# CITY PLANNING COMMISSION

- APPLICATION:
- A. Negative Declaration
  - B. Variance to allow valet parking for all required parking
  - C. Variance to reduce required parking from 70 to 49 spaces
  - D. Variance to waive the required four foot on-site planter

LOCATION: 1310 Alhambra Boulevard

APPLC. NO. P87-002 MEETING DATE January 22, 1987 ITEM NO 10  
3-12-87 4

# EXHIBIT "A"

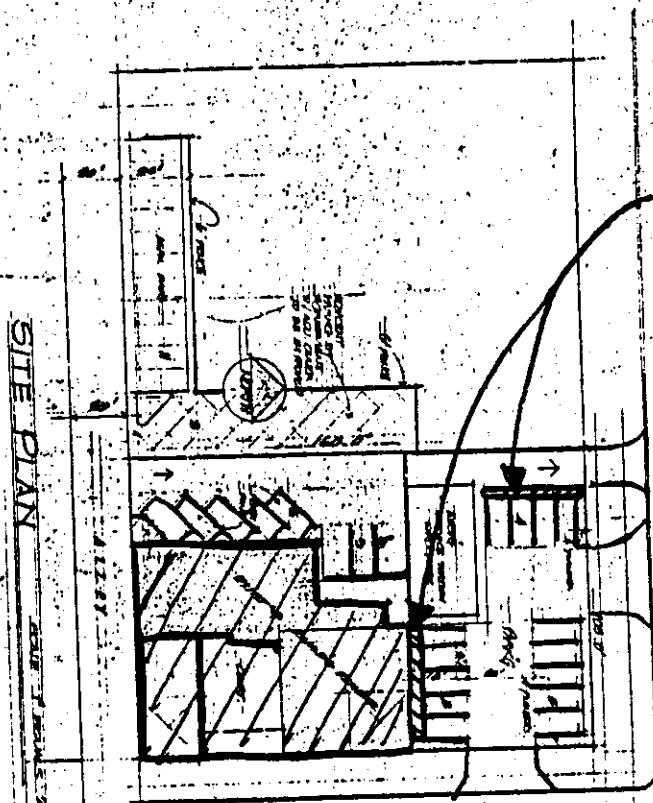
based on a 66 seat restaurant with 22 on-site parking spaces. The existing service station building and a portion of the restaurant structure was shown to be converted to office use at a future date. A condition of approval was that additional planting be provided as indicated by Exhibit A. This parking design provided from 20 to 22 parking spaces and provided the required four foot planters.
